Subject: Responses to Cygna Questions from the Independent Assessment Program  
Reviews  
Comanche Peak Steam Electric Station  
Independent Assessment Program - Phase 4  
Texas Utilities Generating Company  
Job No. 84056

TEXAS UTILITIES GENERATING COMPANY  
COMANCHE PEAK STEAM ELECTRIC STATION  
G&H PROJECT NO. 2323  
CYGNA PHASE IV CABLE TRAY SUPPORT REVIEW QUESTIONS  
REF: CYGNA LTR 84056.031 DTD. 8-6-84

Gibbs & Hill, Inc. Job No. 2323 Client TUGCO  
 Subject CABLE TRAY SUPPORTS - RESPONSE TO CYGNA PHASE 4 REVIEW  
 Calculation Number SCS-101C SET 3 Sheet No. 222

From calculation SCS-101C Set 3, sheet 95

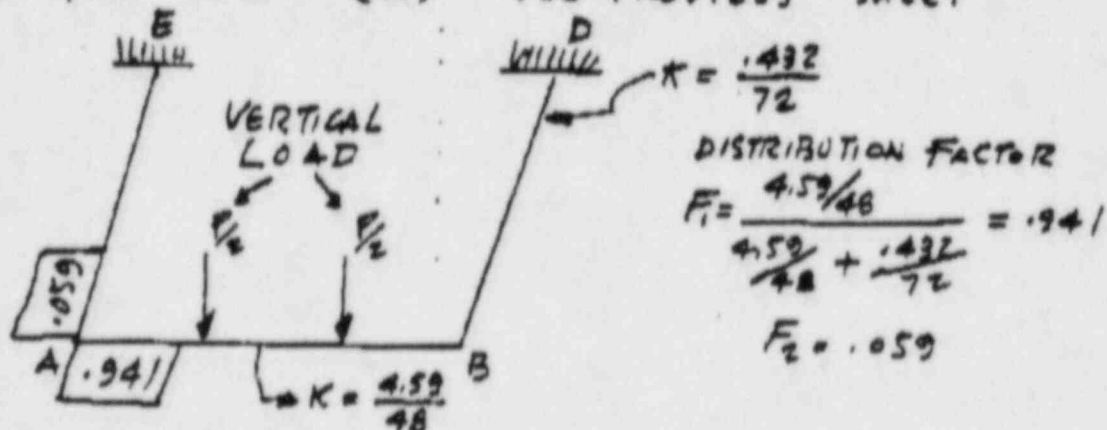
The brace design appears on sheet 94 of reference 2. The design does not consider moments induced through the fixed connection at the frame. These moments would also be induced into the anchor bolt connections but were not considered. In checking the adequacy of the member, a comparison is made between axial force and allowable axial stress. A proper comparison would require checking applied and allowable stresses.

- (f) As shown in item (d) above, the moment to be carried to the brace connection base angle is 0.63 K or  $\frac{.63}{6} \times \frac{6}{4} = 0.16 K$  as additional shear and tension.

$$T = [ 2.69^2 + .16^2 ]^{.5} = 2.694K$$

$$V = [ 1.79^2 + .16^2 ]^{.5} = 1.8K$$

This shows that there is no significant change.

Question 2.1.1 Major and Minor Axes Flexure  
 (CYGNA Letter # 84056.031 DATED August 31, 1984)

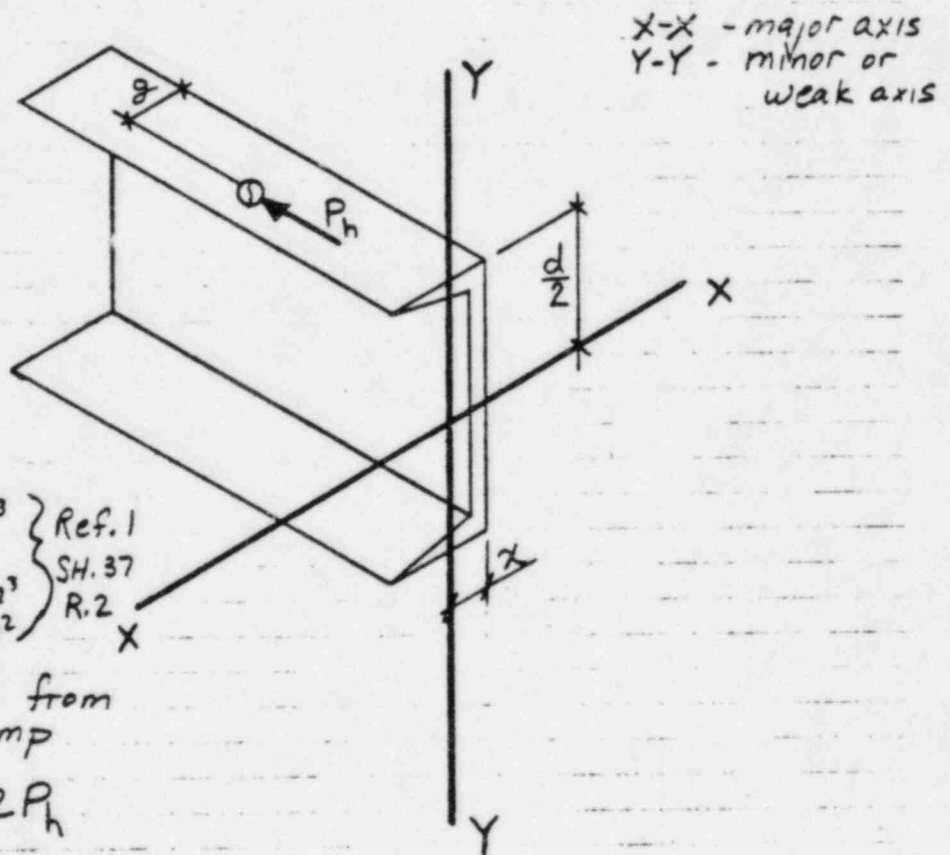
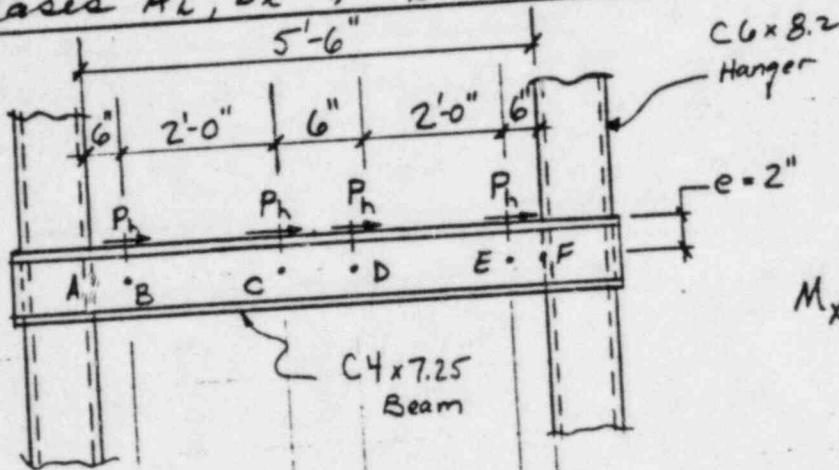
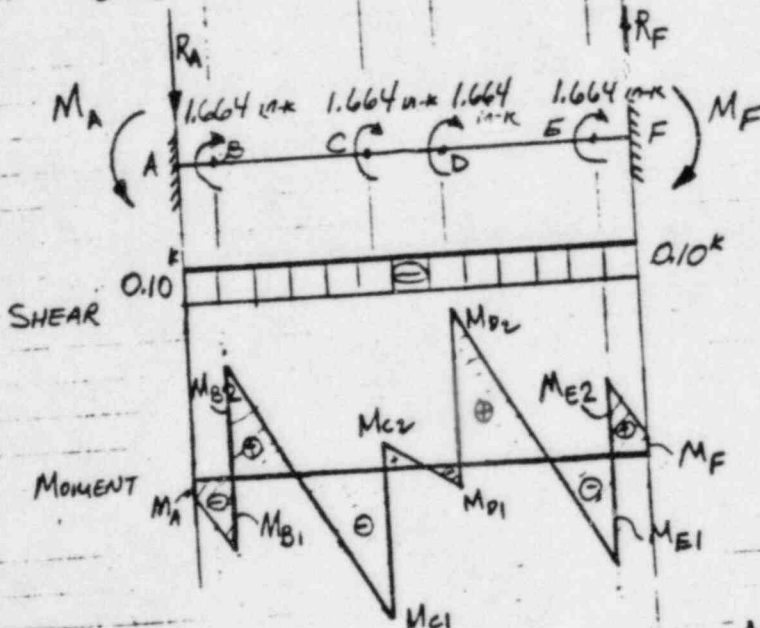
As noted in Figure 2B, the location of the transverse load,  $P_h$ , is eccentric to the major axis by a distance  $d/2$ , where  $d$  is the channel depth. The effect of this eccentricity is an increase in major axis bending. Minor axis bending will occur because  $P_h$  is eccentric to the minor axis by a distance of  $(g-x)$  where  $g$  is the gage distance and  $x$  is the location of the neutral axis relative to the back of the channel web.

Purpose of Calculation - To provide justification for neglecting the effects of eccentric transverse loading on beam channel sections typically used in the cable tray support designs.

Reduced  $S_{x-x} = 1.948 \text{ in}^3$  } Ref. 1  
 Reduced  $S_{y-y} = 0.297 \text{ in}^3$  } SH. 37  
 Reduced Area =  $2.003 \text{ in}^2$  } R. 2

$$M_{xx} = 2P_h = 2(.832) = 1.664 \text{ in-k}$$

Question 2.1.2 (cont)  
Justification:

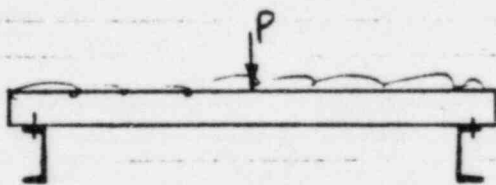
As shown in Figure 2C, vertical cable tray loads are applied eccentrically to the shear center of the channel section which induces torsional moments into the beam. Cygna has noted that only beam members for Regular Case cable tray supports Details A<sub>1</sub>, B<sub>1</sub> and C<sub>1</sub> and Detail SP-7 with brace have been analyzed for the effects of eccentrically applied vertical loads. Cygna is currently reviewing these calculations. No other cable tray supports have been analyzed for the effects of torsion due to vertical loads.

Torsional stresses caused by loads acting in the plane of the minor axis of a channel member are generally neglected in engineering practice if the support arrangement is symmetrical about the center line of the system as illustrated below:

Question - 2.1.3: (CYGNA LTR #4056.031 ATTACHMENT A)  
 TORSION DUE TO LONGITUDINAL LOADS

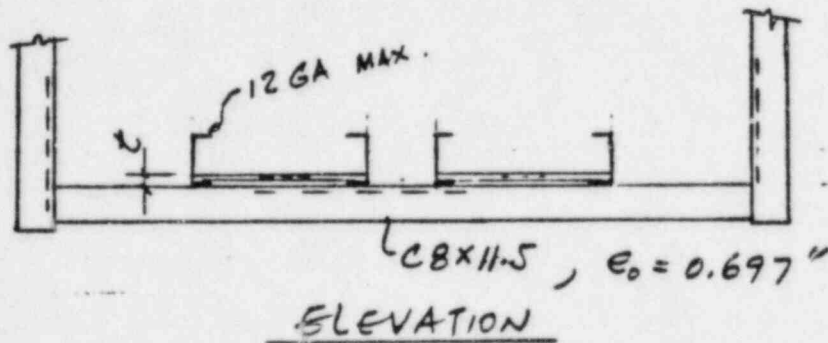
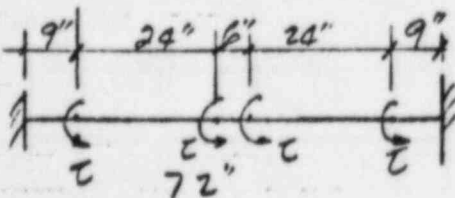
As shown in Figure 2C, longitudinal cable tray loads are applied eccentrically to the major axis (X-X) of the channel section which induces torsional moments into the beam member. Cygna has noted that only Detail SP-7 with brace has been analyzed for the effects of eccentrically applied loads.

Purpose: To provide justification for the longitudinal cable tray support beam to resist the additional torsional effects due to the eccentric longitudinal tray leads.

Group 1: L-A<sub>i</sub>, L-B<sub>i</sub> & L-C<sub>i</sub>, i = 1 to 4

QUESTION 2.2 (CONT'D)

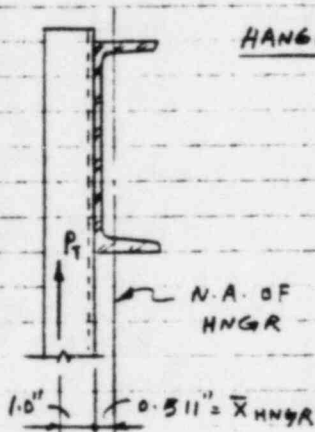
The cable tray supports are primarily constructed of channel sections for the hanger and beam members and angles for bracing members. (For Cygna's concerns regarding angles, reference Cygna's letter 84056.027, question 2.) Figure 2D shows the eccentricity between the neutral axis of a typical beam and hanger connection. Cygna has noted that the effect of this joint eccentricity has not been considered in the design calculations.

i) EFFECT OF ECCENTRIC CONN. FOR THE TRANSVERSE LOADS:  
 REFER TO THE STIFFNESS ANALYSIS SHOWN ON SH. 156 TO 158 R4

HANGER  $\Delta M^T = P_T \times \frac{r}{12}$   
 REF. TO SH. 160 R.4  
 $\Delta P_T = 0.2322 \Delta M^T = 0.2322 P_T \times \frac{r}{12}$   
 $= 0.0193 r P_T$

PLAN  $\frac{\Delta P_T}{P_T} = 0.0193 \times 1.511 = 0.029$   
 $= 2.9 \%$
